From: [REDACTED]
To: [REDACTED]
Cc: [REDACTED]
Subject: RE: MP06_0258 MOD 10 Casuarina Town Centre
Date: Wednesday, 31 October 2018 4:38:43 PM
Attachments: [image003.png](#)
[image004.png](#)
[image005.png](#)
[Open Space Dedication Plan.pdf](#)

From: Natasha Harras [REDACTED]
Sent: Thursday, 1 March 2018 11:05 AM
To: Damian Chapelle [REDACTED]
Cc: Anthony Witherdin [REDACTED]; Emma Butcher [REDACTED]
Subject: MP06_0258 MOD 10 Casuarina Town Centre

CLIENT	PROJECT	TITLE
CLARENCE PROPERTY	CASUARINA BEACH	SITE LAYOUT PLAN

CASUARINA BEACH
TOWN CENTRE - STAGE 2
CASUARINA WAY, NSW 2487

PROJECT No.	DRAWING No.	REV.
B16097	C-0003	E

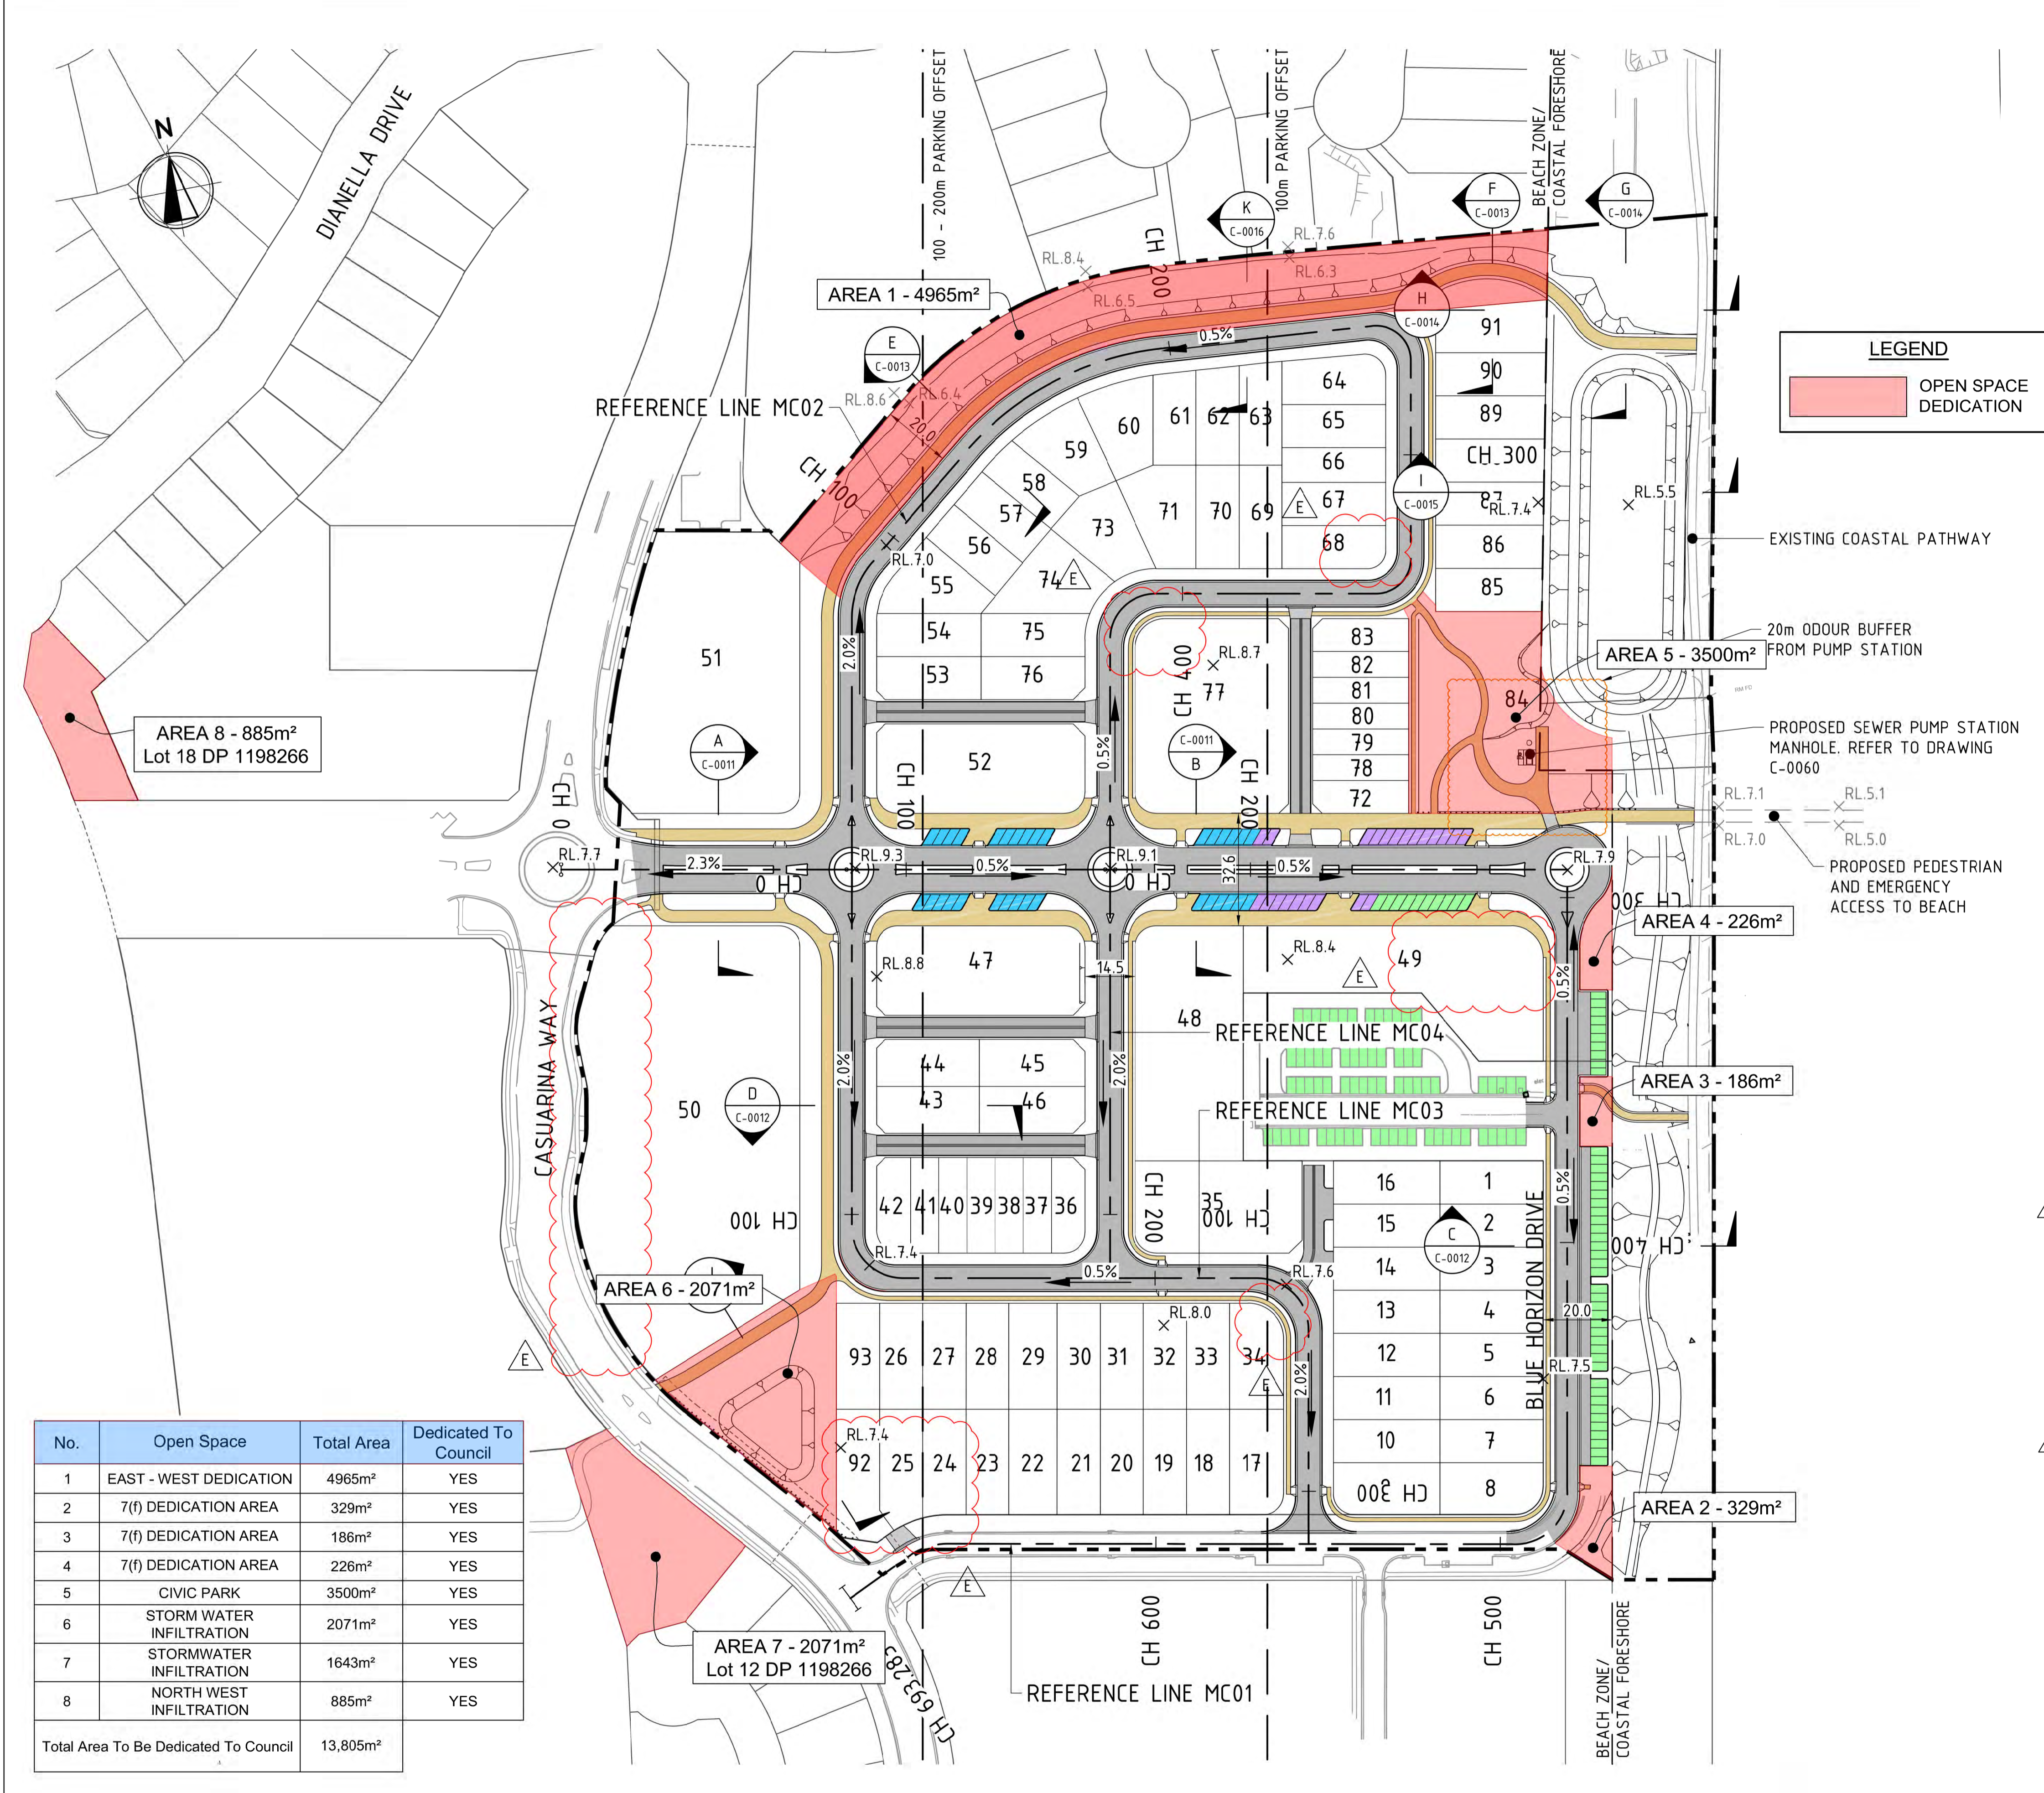
I refer the Commission to the below email from Ms Natasha Harras and the figure at the bottom of her email which clearly illustrates the total open space of 16,450sqm relates to the entire Casuarina Town Centre. I then draw the Commission to the attached BG&E Plan C-003 (Site layout Plan) which illustrates the open spaces area are provided only for the area subject to Mod 10. As a result, in stating our proposal provides 13,805sqm, this does not reflect the fact areas 4 & 6 totalling some 1,694sqm, which sits outside the Mod 10 land area has not been included in the comparison open space calculations for our assessment. That is, the open space area of 13,805sqm relates solely to the area subject to Mod 10 and not the entire Casuarina Town Centre approved under MP06_0258. When this area is included to our proposed open space provision, a total open space dedication area of 15,499sqm is achieved. Accordingly, a reduction in open space of 951sqm and not 2,645sqm for the entire Casuarina Town Centre will result. The reduction in area is primarily as a result of the re-alignment of the cycleway.

- Please confirm that the line of the shared path though this allotment is proposed to be as per the updated Site Layout Plan C-0002 Rev E dated 1.2.18 as opposed to all other earlier plans.

Please see below the area calculation for the entire Casuarina Town centre. The area to be dedicated within Precinct B & C equates to 12,596sqm under the current approval (Areas 1, 3 & 5). The proposed modification provides for 11,297sqm (refer to attached plan & areas 1-6). The reduction is generated through the loss of the cycleway between Santai and Lot 51 and 200sqm from the civic park.
